FALCON RESERVE FILING NO. 1

CONSTRUCTION PLANS

JULY 2026

FALCON RESERVE FILING NO. 1
EXTENTION AND STRIPING PLAN

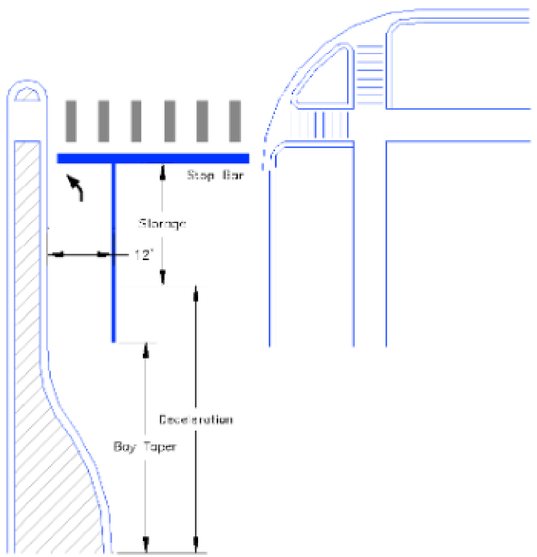
Please adjust this striping plan to match Figure 2-25 of the ECM. this plan is a two way left turn design
